# PLAN COMMISSION MEETING NOTICE AND AGENDA Thursday, September 16, 2021 6:00 PM

### CITY OF PEWAUKEE PLAN COMMISSION AGENDA ITEM 2.

#### REPORT TO THE PLAN COMMISSION

# 2 18-UNIT 2ND FLOOR PLAN SCALE: 1/8" = 1'-0"

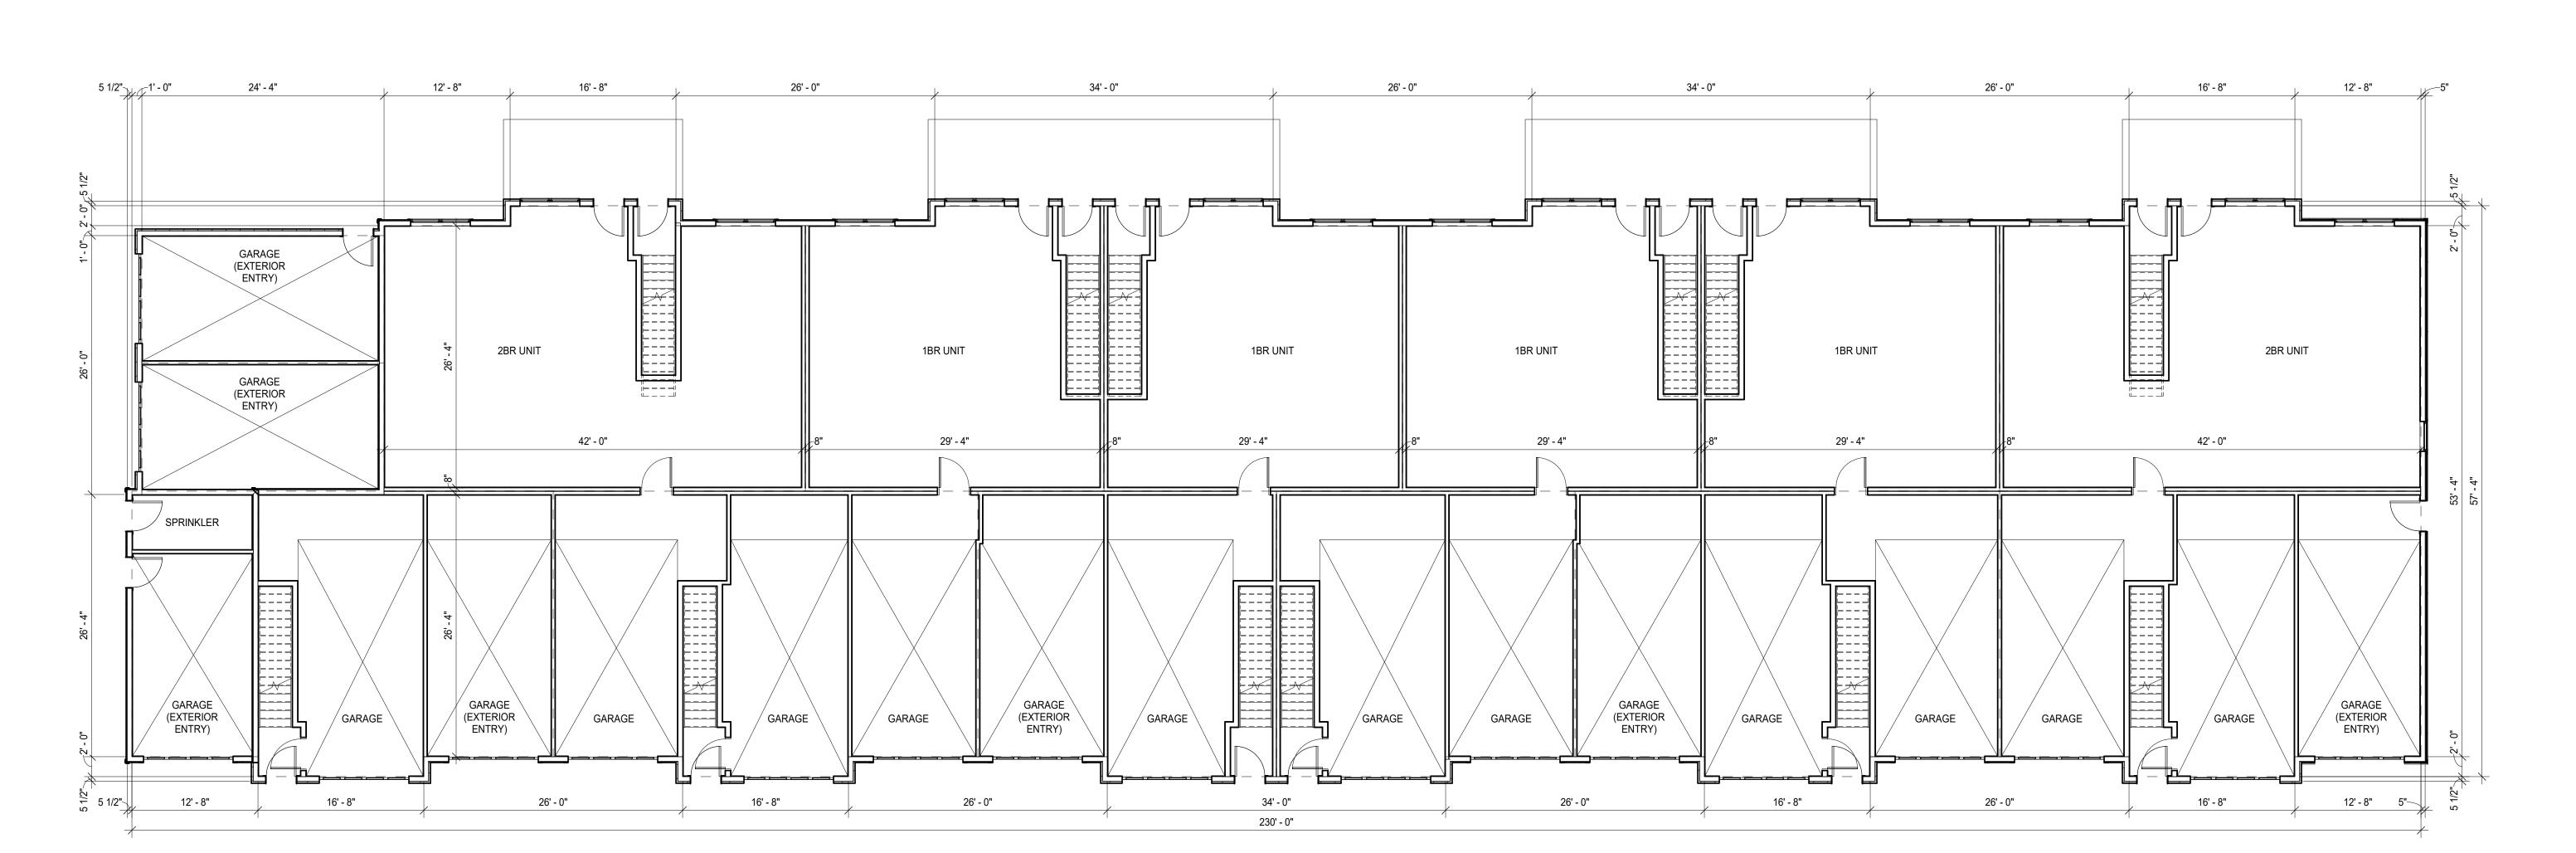
- 3. Please confirm that all one-bedroom units will be at least 650 square feet and two-bedroom units a minimum of 800 square feet. Note added to sheets A101 & A102.

- 4. Note all bedrooms must be at least 100 square feet in area, exclusive of closets. Note added to sheets A101 & A102.
- 5. Please show the stream and 75-foot OHWM setback on Sheet EX1.0. Stream and approximate OHWM location added to sheet EX1.0 (to be coordinated/verified with DNR).

ALL ONE BEDROOM UNITS TO BE OVER 750sf
 ALL TWO BEDROOM UNITS TO BE OVER 1,050sf
 ALL BEDROOMS ARE OVER 100sf (EXCLUSIVE OF CLOSETS)

SHEET 18-UNIT BUILDING ELEVATIONS

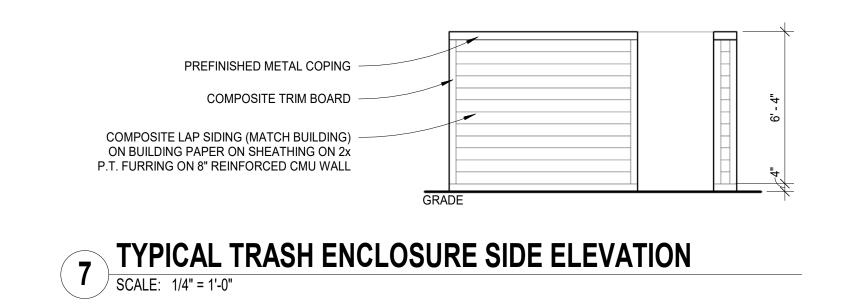
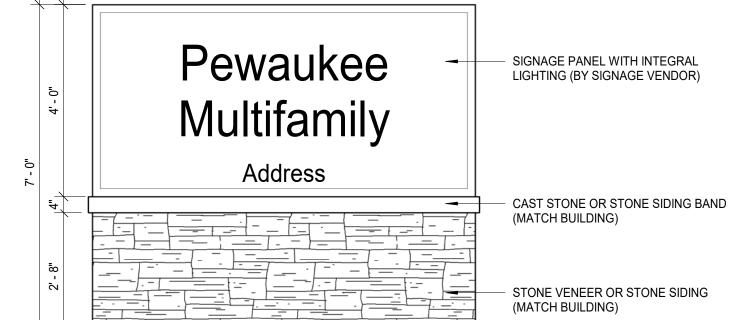
- 19. Please dimension a typical parking space size on the site plan. Typical 9'x20' parking space size (180sf) added to sheet SP1.1.
- 20. The shake siding (material #8) is not illustrated correctly on Sheet A402 for the 18-unit building. Please revise accordingly. Graphic revised on sheet A402.

5 MONUMENT SIGN ELEVATION
SCALE: 1/2" = 1'-0"

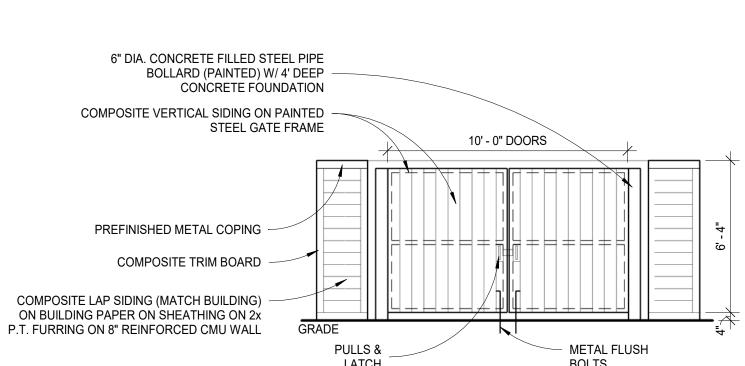
A monument sign is shown on the site plan adjacent to Watertown Road. Additional sign details can be found on Sheet A403. The proposed sign has a peak height of 7-feet. The proposed sign area is 4' x 8' (32 square feet). The base of the sign is stone to match the buildings. Unless Plan Commission objects to the proposed signage as shown and requires further review, <u>a Sign Permit shall be submitted and</u>

approved by staff that is in substantial conformance with the sign shown on Sheet A403 and the site plan, prior to installation.

- 12. A monument sign is included in the plans. Please illustrate its proposed location on Sheet EX1.0 or SP1.1. Please be aware that the Plan Commission will consider the proposed signage as to the quantity, size, height, and type (17.0210d.(7)). Following Plan Commission approval, signs will require separate sign, footing and electrical permits, as may be necessary, issued through the Building Services Department. Understood. Proposed monument sign location is shown on sheet SP1.1, east of the site entrance from Watertown Road.

3 CLUBHOUSE RIGHT SIDE ELEVATION SCALE: 1/8" = 1'-0"

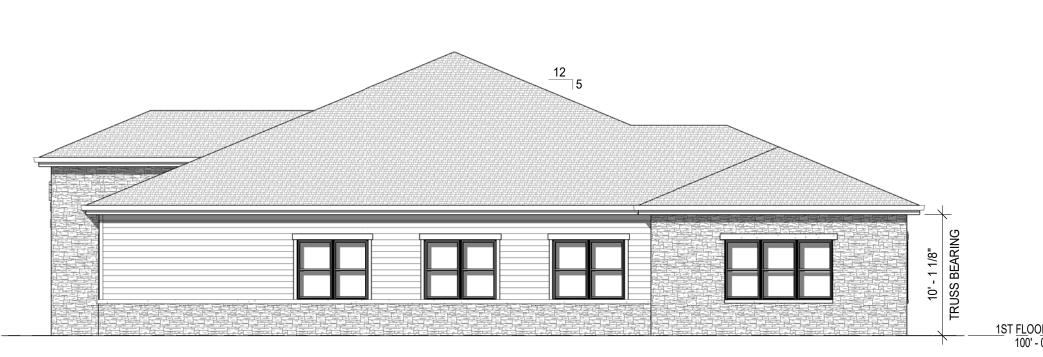
- 11. It is recommended that the overhead door on the clubhouse be more decorative and contain windows, similar to the doors on the residences. Decorative overhead door with windows added to sheet A403.
